East Anglia THREE DCO Non-Material Change

Supporting Statement

PROJECT: East Anglia Three Offshore Windfarm

Doc. ID.: EA3-GEN-CON-REP-IBR-000276

Figure 1: 262m Tip Height Turbine Model Indicative Layout – 121 Turbines (Plus 1 Offshore Substation)

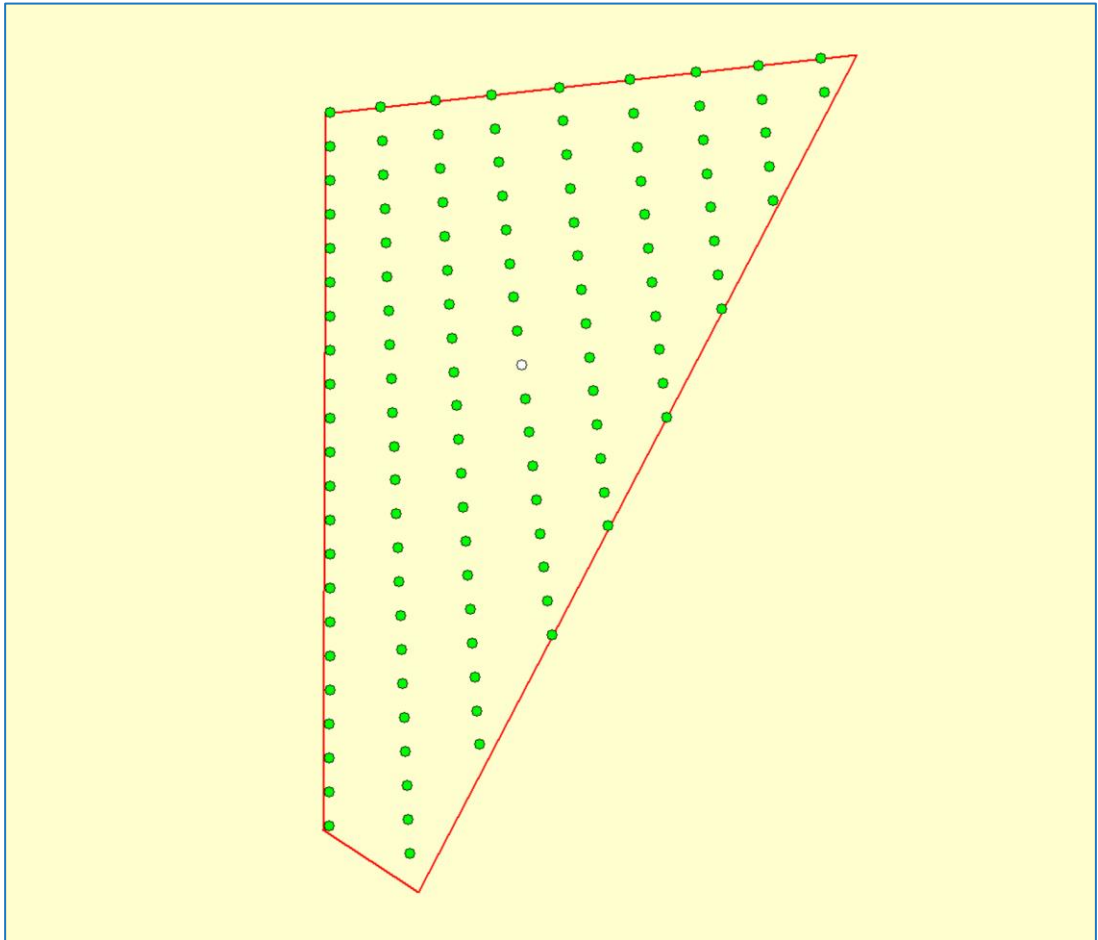
1.4.5.5. This turbine layout represents a realistic worst case for radar modelling purposes. Earlier indicative layouts were utilised to inform radar modelling in the Environmental Statement. The key consideration remains radar line of sight. The layout being utilised here provides specific test points across the entire East Anglia THREE footprint where turbines may be deployed in order to assist aviation stakeholders to fully assess the proposed NMC.

Figure 12: Revised Radar Line of Sight Coverage Plan

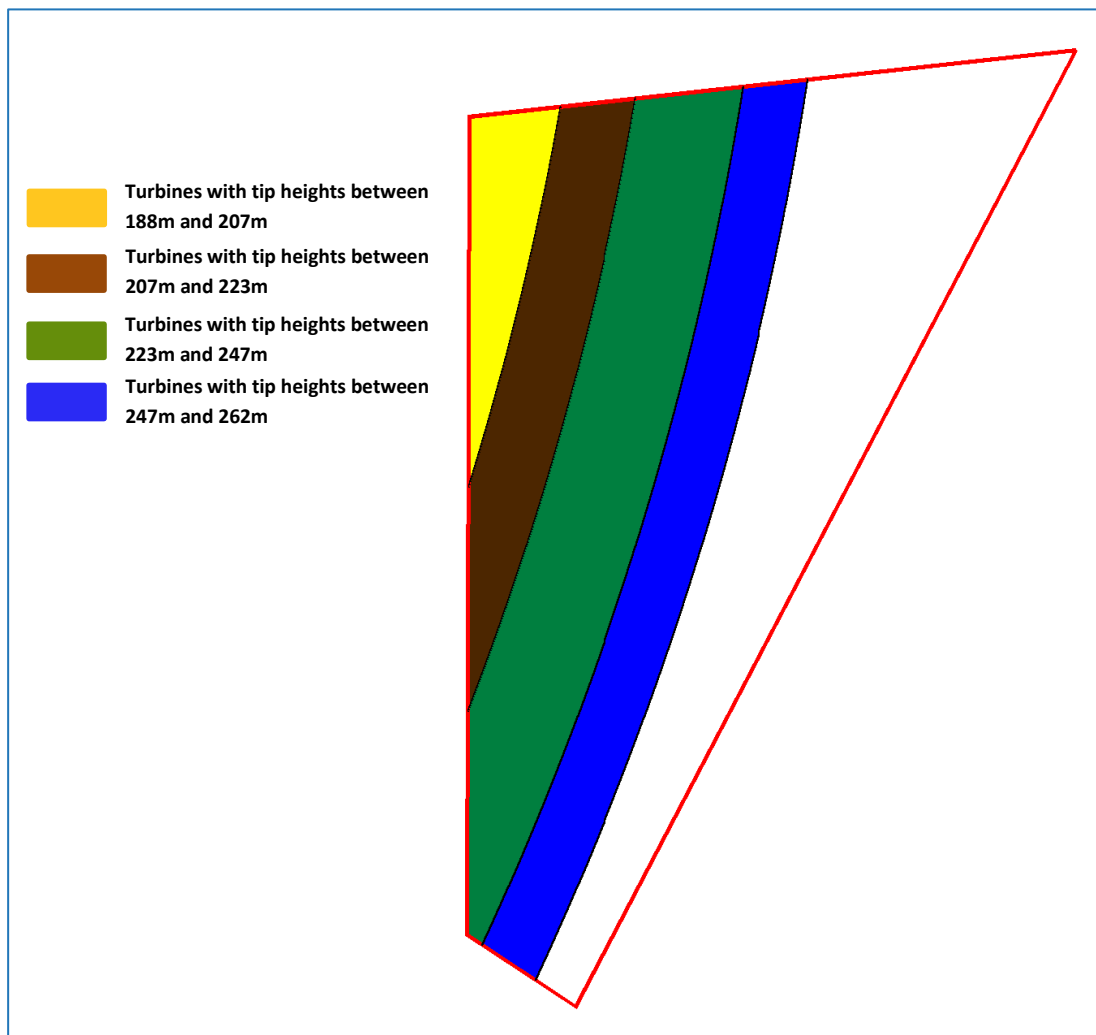
- 1.6.4.2. Calculations in Appendix 16.1 of Volume 3 of the Environmental Statement have already indicated that, in the absence of detailed technical data on the TPS-77 radar, PD and RLoS can effectively be treated as the same for Trimingham radar. This means that wind turbines in the indicative layout with a tip height of 189m or less would be below the RLoS of the Trimingham radar and would require no further mitigation. If the wind turbine tip heights exceed the relevant RLoS heights as shown in Figure 9 in those areas, then it can be assumed that any turbines in RLoS of Trimingham radar will be detected by the radar and a technical mitigation solution will be required for the MOD Trimingham radar. DCO Requirement 33 provides for such mitigation, albeit a minor amendment is required to reflect Figure 12 below. The Radar Line of Sight Coverage Plan (document 2.11, as certified under the DCO) also requires revision so as to reflect Figure 12 below.

Radar Line of Sight Coverage Plan

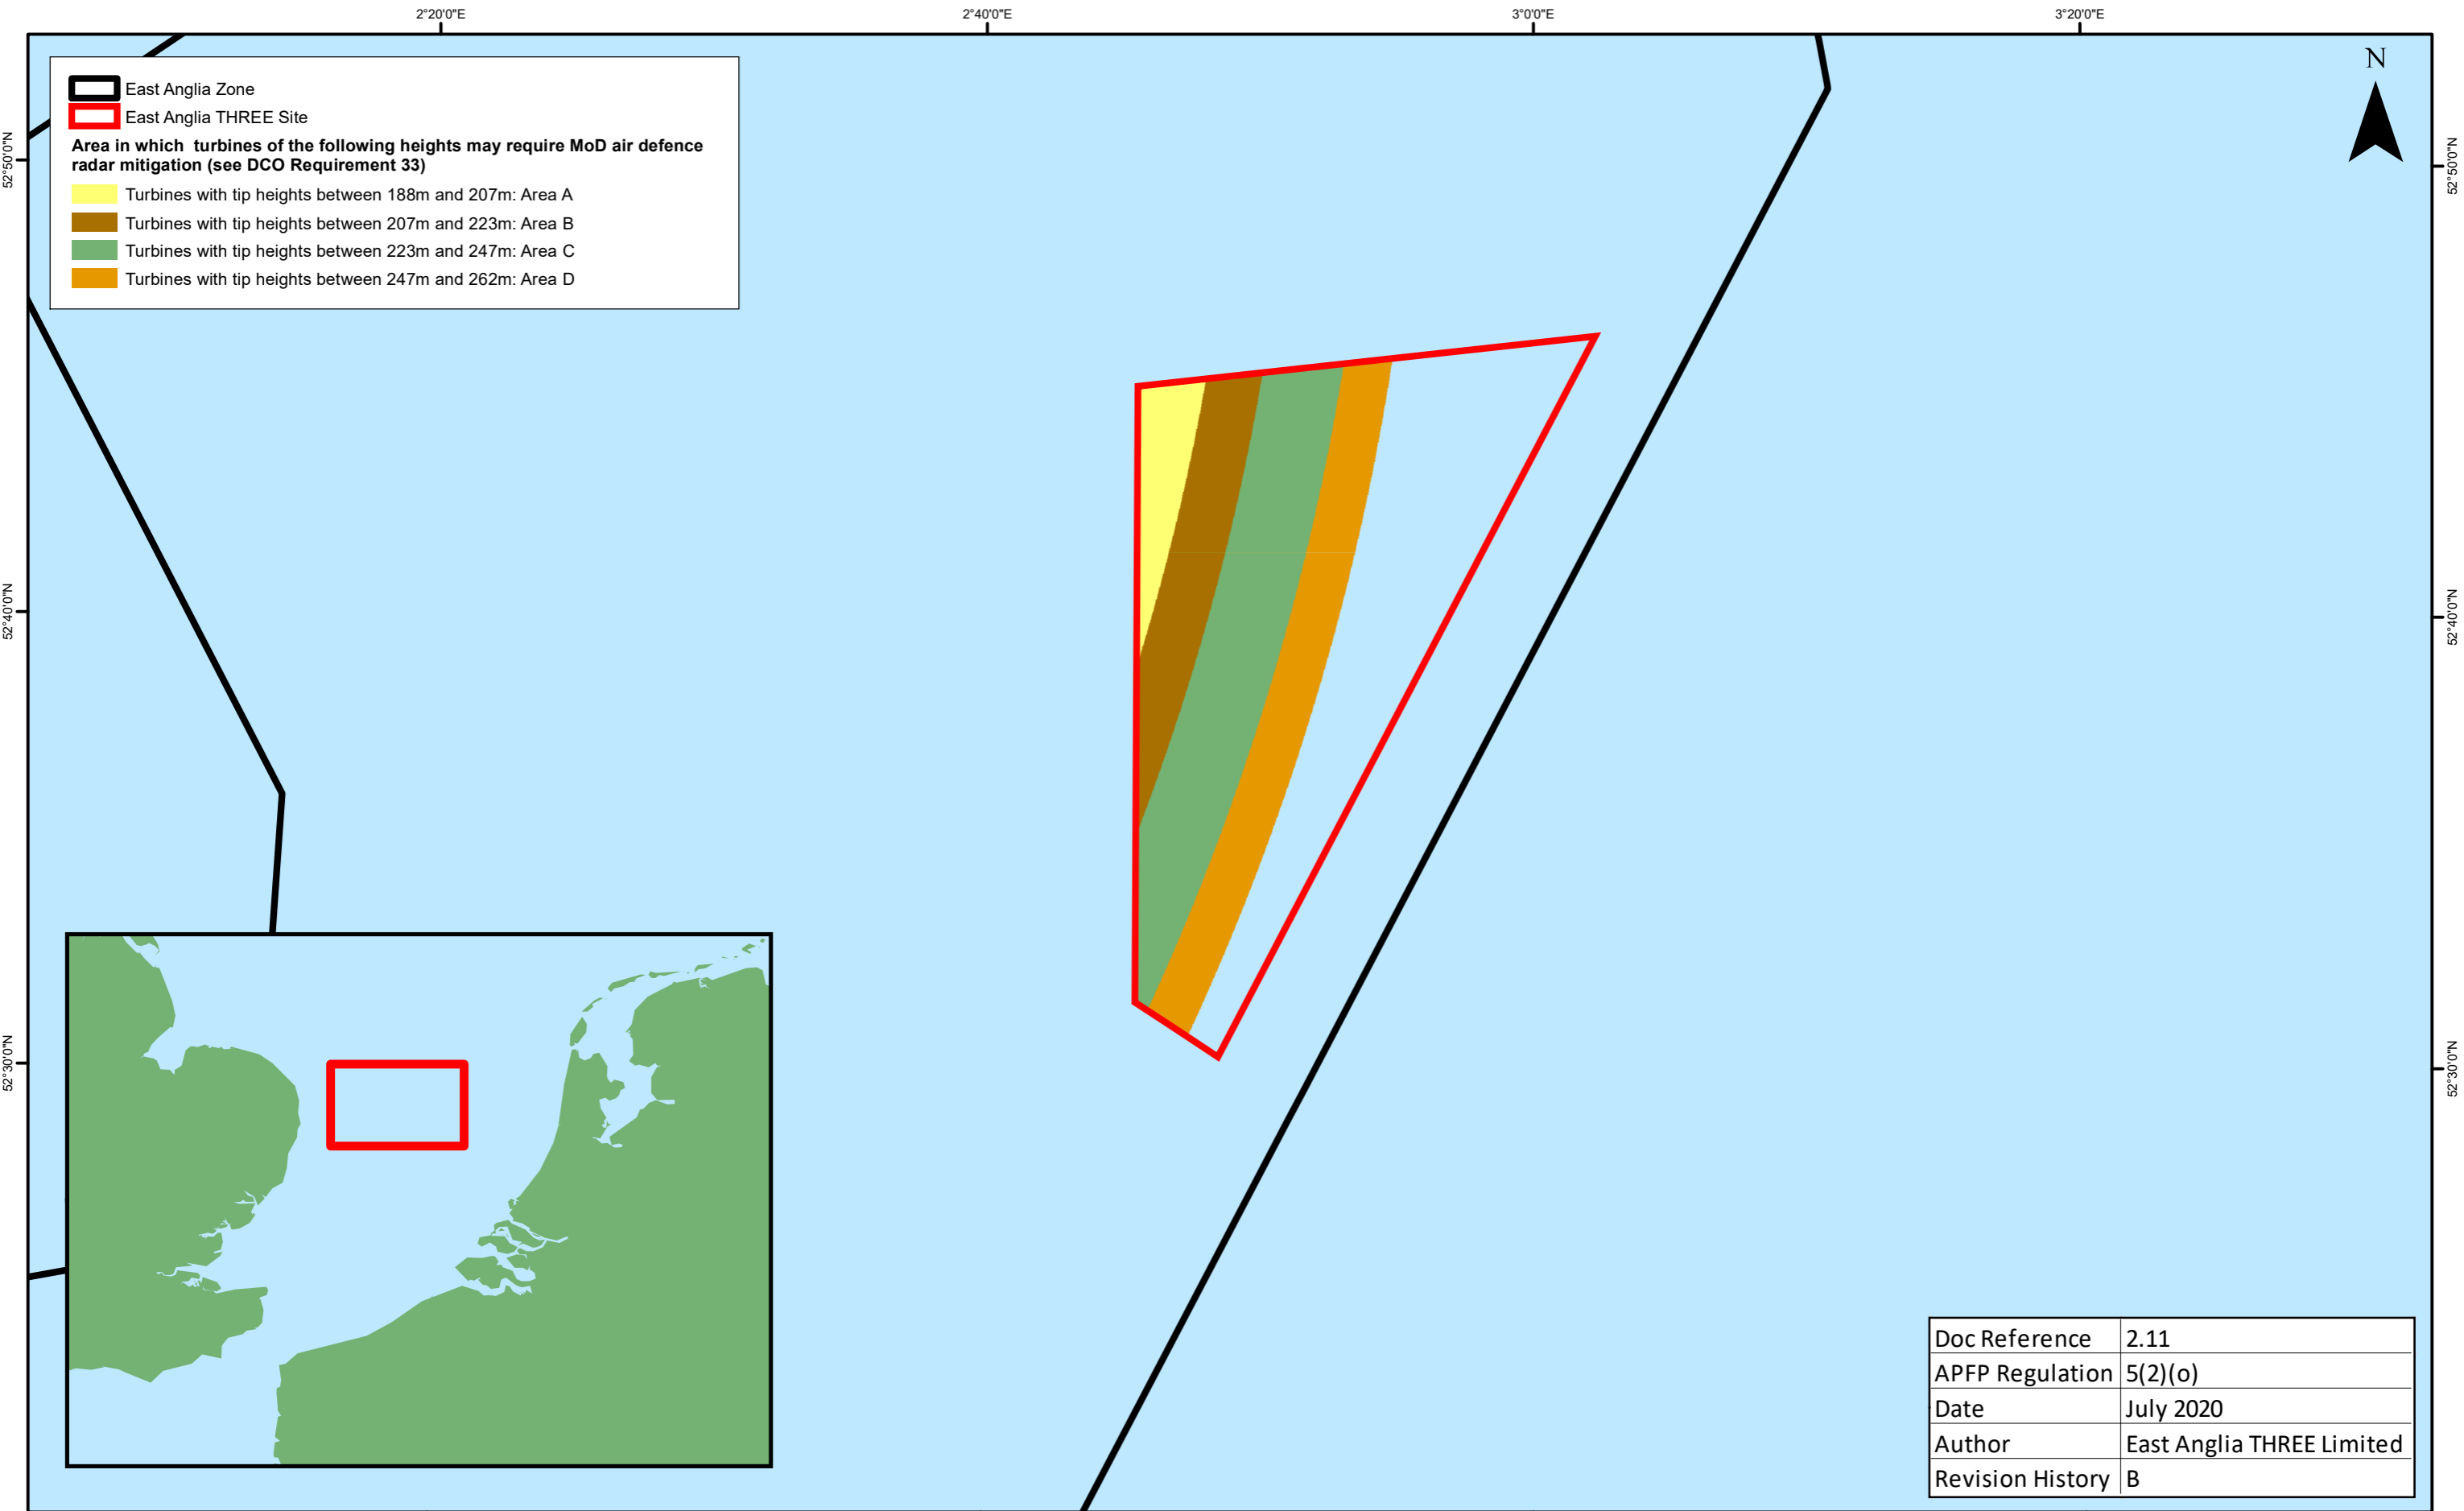
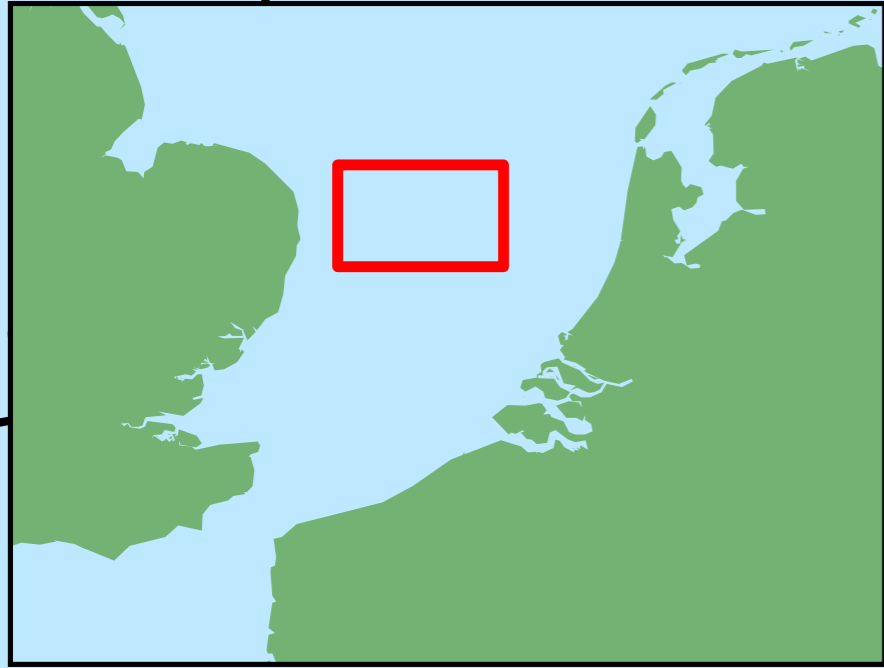
Area in which turbines of the following heights may require MoD air defence radar mitigation (see DCO Requirement 33)

- Turbines with tip heights between 188m and 207m: Area A
- Turbines with tip heights between 207m and 223m: Area B
- Turbines with tip heights between 223m and 247m: Area C
- Turbines with tip heights between 247m and 262m: Area D
